NHTSA SAFETY RECALL

Safety Recall Notice #07V-355 Tachometer Board Update Remedy

BULLDOG TACHOMETER CIRCUIT BOARD IMPROVEMENT INSTRUCTIONS Recall # 07V-355

Apply a liquid-type electrical tape in area shown.

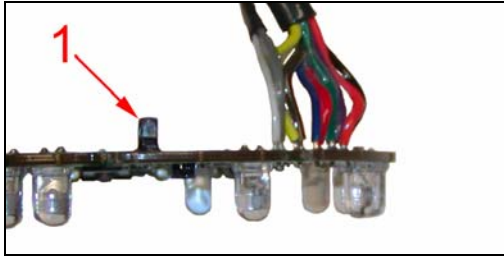
6. The tachometer circuit board is retained with a snap ring. Remove the snap ring from beneath the retaining tabs.
7. Lift tachometer circuit board from bezel.
8. Apply a liquid-type electrical tape to the tachometer harness wires where they are soldered to the circuit board in area shown below.

1. Remove data port connection.

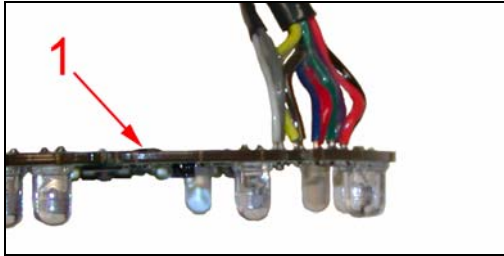
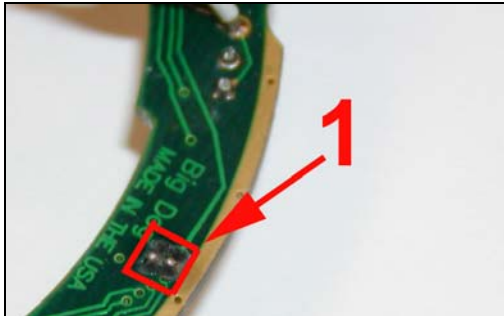
9. Use **only** a "flush-cut" style cutter to remove the data port connector from the tachometer circuit board shown in the next images. The cut wire leads **must not** contact each other.

1. Data port connection removed. Apply liquid-type electrical tape.

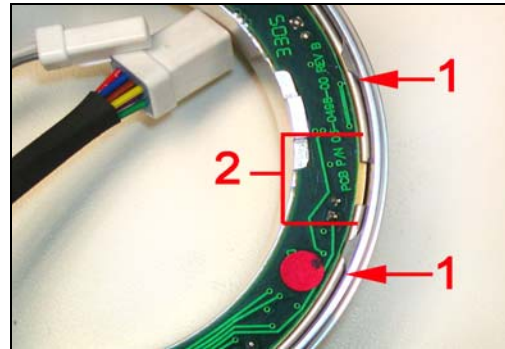
10. Once data port connection has been removed, cover exposed area with a liquid-type electrical tape.
